PROJECT NAME: AZALEAS SKILLED NURSING FACILITY

PROJECT NUMBER: 2025010041

APPLICATION: MAJOR SITE PLAN #32388

SHEET NUMBER 05

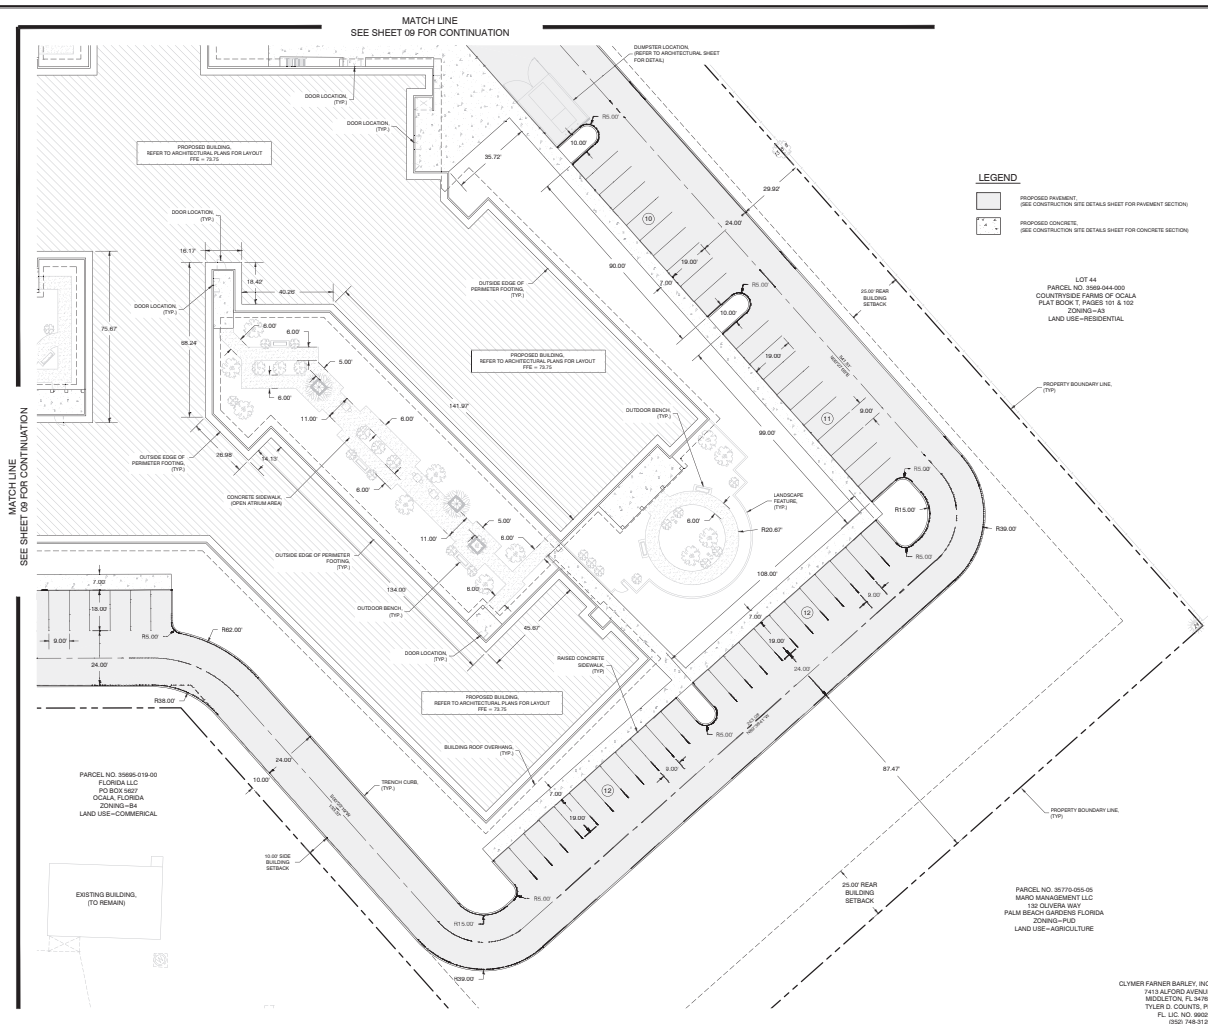
REMARKS: The Special Use Permit for this project was approved. Per LDC Sec. 2.12.4.L.(4), add the case permit number and resolution number to the cover sheet and site data table on sheet 05.

SHEET NUMBER 08

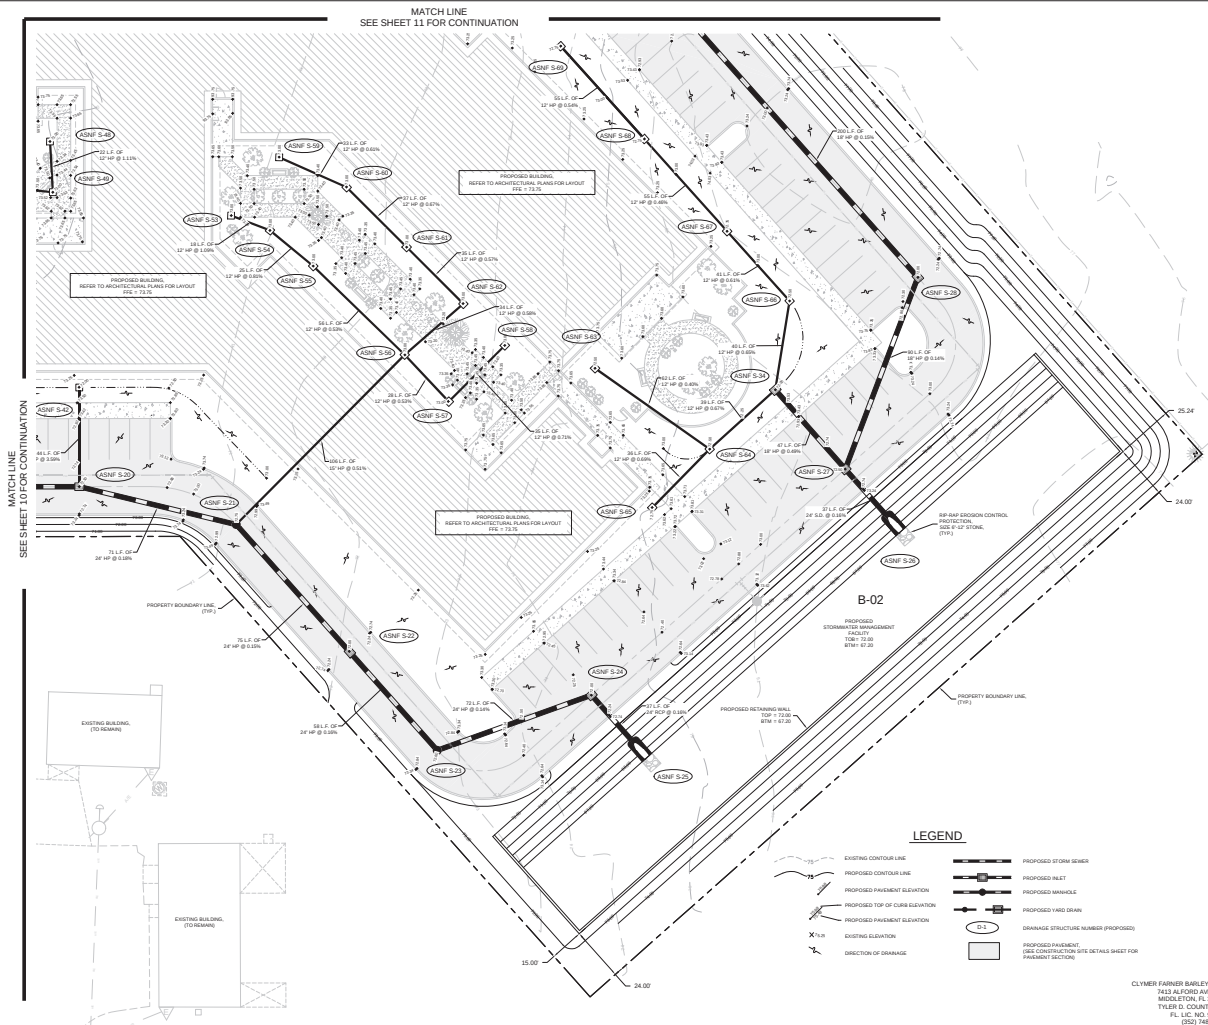
[1] Buffers need to be shown, dimensioned and labeled on the site plan sheets 5 through 8, consistent with the landscape plan. For the Type B buffer along the site's east boundary, specifically label the buffer as a Type B Buffer w/ 6' pillar/panel buffer wall.

AZALEA SKILLED NURSING FACILITY
MAJOR SITE PLAN
MARION COUNTY, FLORIDA
MASTER DRAINAGE PLAN

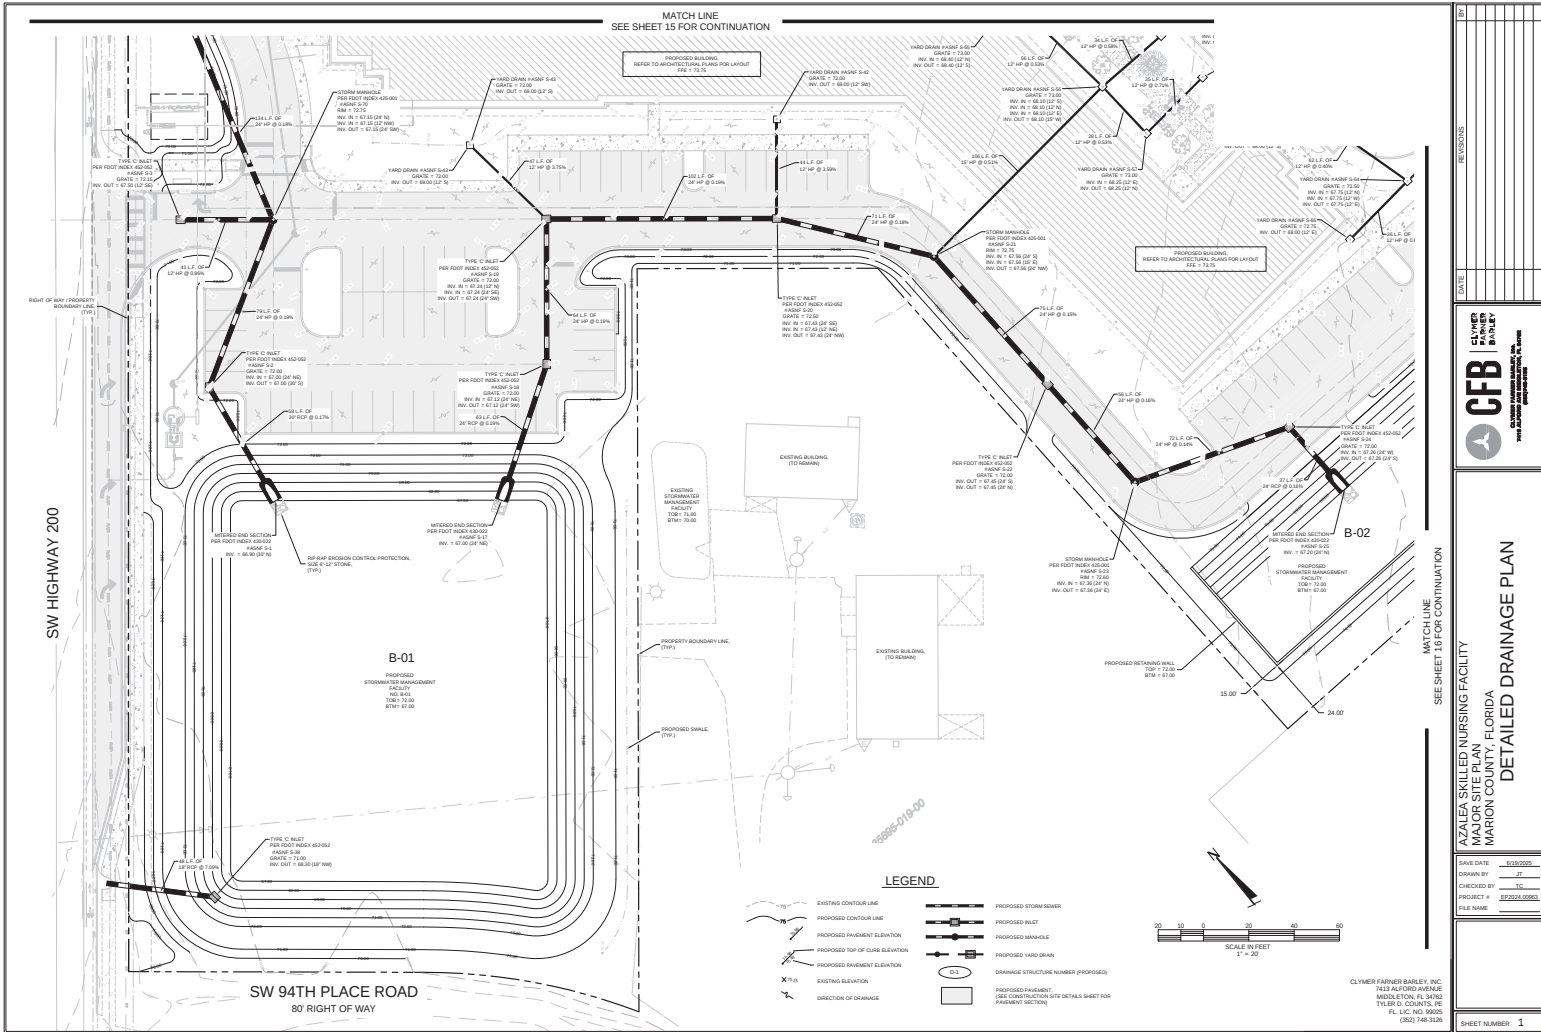
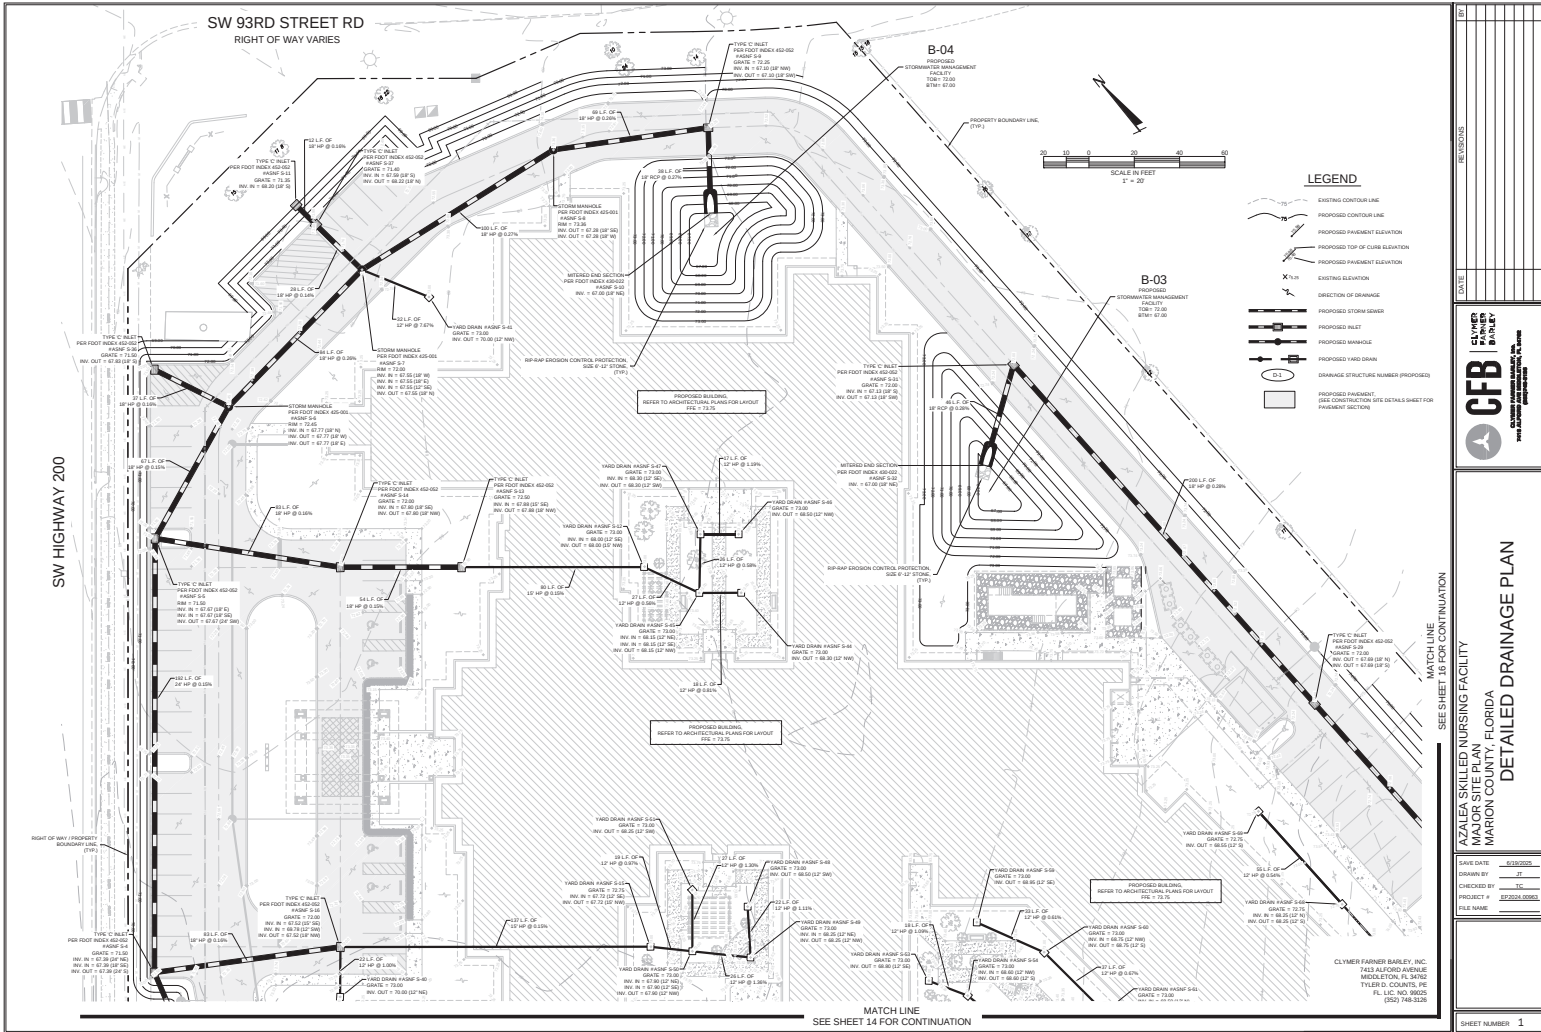
REMARKS: Please label all yard drains and stormwater inlets with FDOT reference or provide details for all structures.

REMARKS: (1) Please label all proposed pipes with sizes and materials. (2) The drainage plan appears to depict multiple stormwater pipes routed underneath the proposed buildings. This is not allowable. Please revise the pipe routing to avoid constructing underneath a proposed building.
